M E M O

TO:	<u>Michael Fabbre, District Manager</u>	DATE:	<u>November 13, 2020</u>
FIRM:	<u>Mt. Crested Butte Water & Sanitation District</u>	JOB NO.:	<u>1028.2e</u>
ADDRESS:	<u>100 Gothic Road</u>	PROJECT:	<u>Hunter Ridge Development - Sanitary Sewer Analysis</u>
	<u>Mt. Crested Butte, CO 81225</u>	SUBJECT:	<u>Capacity Analysis & Results</u>

FIGURE 1 - EXISTING SYSTEM MODEL
 MCBWSD HUNTER RIDGE SANITARY SEWER ANALYSIS
 MT CRESTED BUTTE, COLORADO
 JOB 1028.2e
 JULY 2020

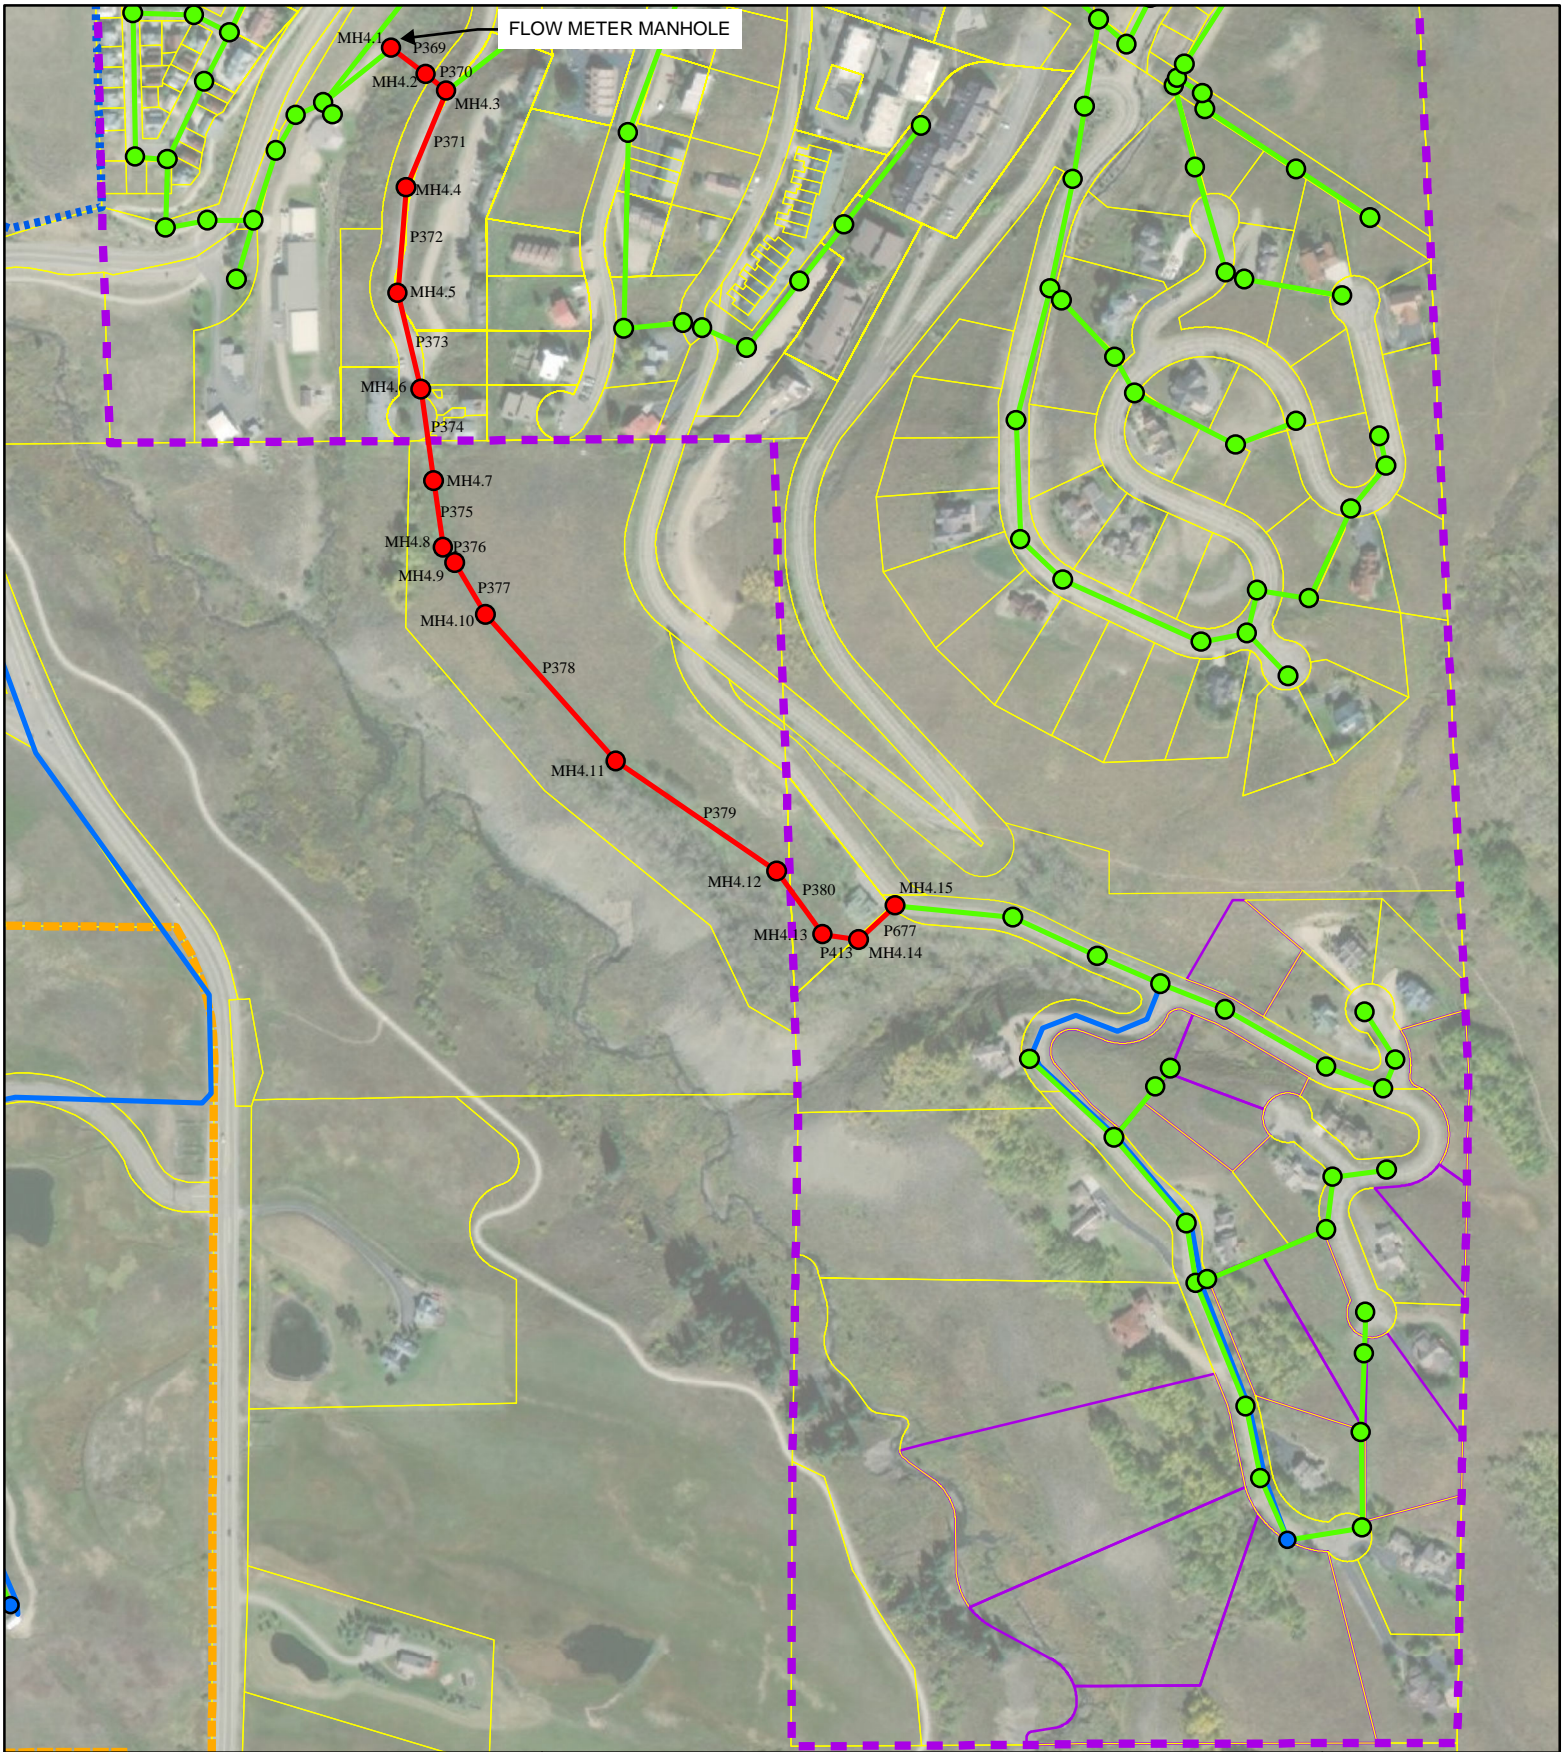
Buildout flows for the vacant single family lots were estimated using the June water use acquired from the District for lots of similar size. The flow for a single lot was identified to be 0.833 gpm. While normally a portion of the water use would be assumed to not reach the sewer system, the entire water use amount was utilized to be conservative. There are currently 12 lots not developed upstream of the modeled system equating to approximately 10.0 gpm. The buildout flow was added to the starting node in the model, manhole MH4.15, to account for buildout conditions. The buildout lots are shown in Figure 1.

FIGURE 3 - HUNTER RIDGE SYSTEM MODEL

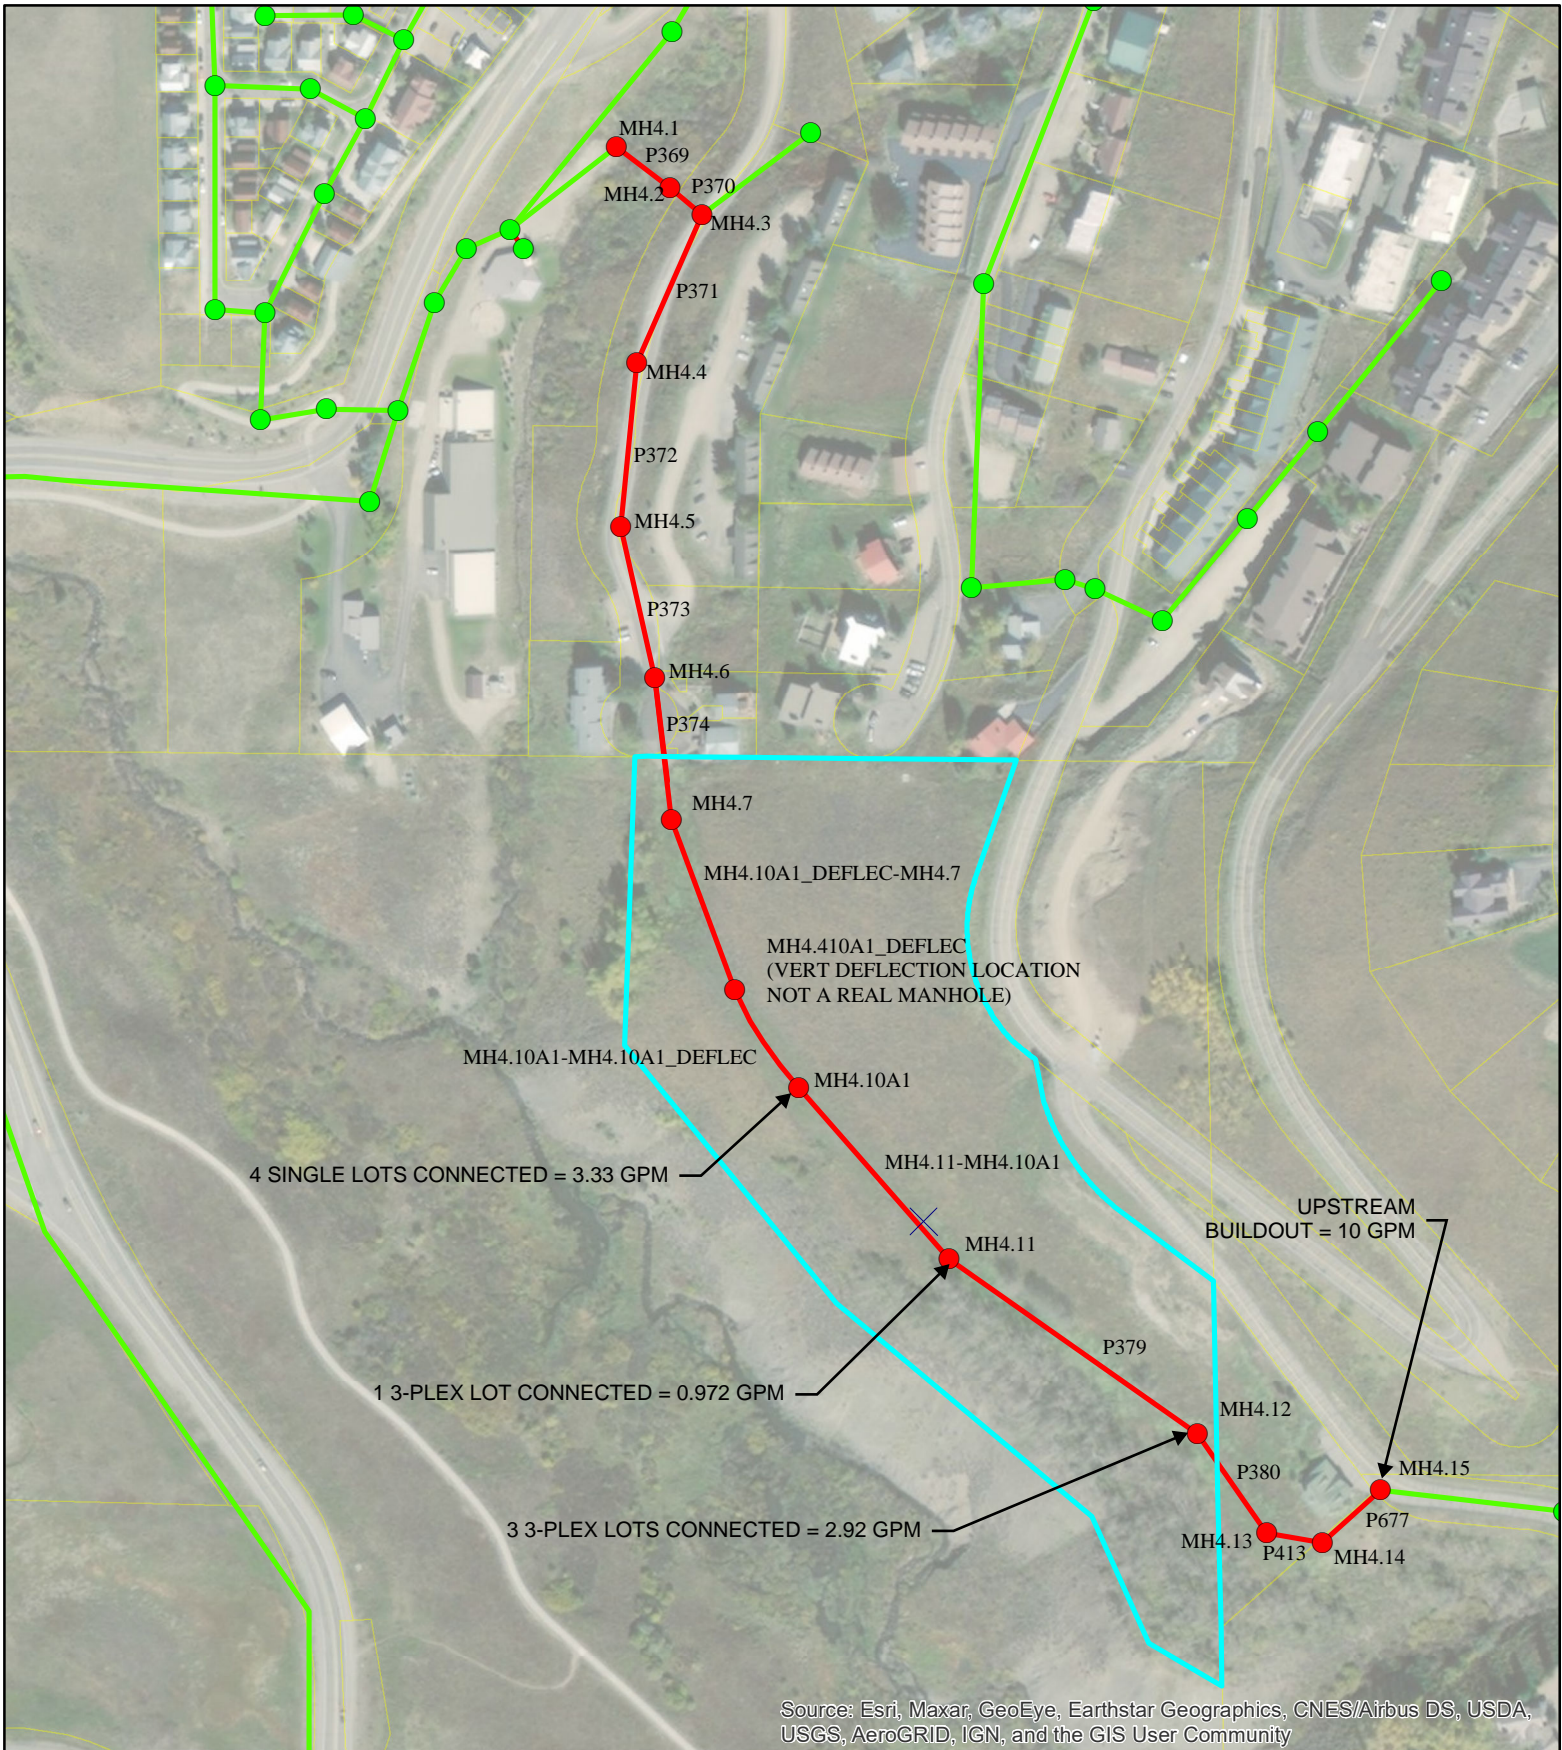
The District provided a preliminary alignment for the sewer system that was designed by NCW Associates, Inc. that would move the sewer main further east outside of the Avalanche Zone and within the proposed roadway and access road. The sewer will remain an 8-inch pipe. The development has 8 lots that will be connected to the system, 4 single family lots and 4 multiunit 3-plex lots. The single family lots were estimated to have a loading value of 0.833 gpm while the multiunit lots were estimated to have a loading of 0.972 gpm based on water use of similar units within the area. Figure 3 shows the location of the proposed sewer main and assumed location of the lot connections. Figure 4 is the profile of the Hunter Ridge sanitary system modeled. Attached are summary tables of the Hunter Ridge model manhole and pipe inputs.
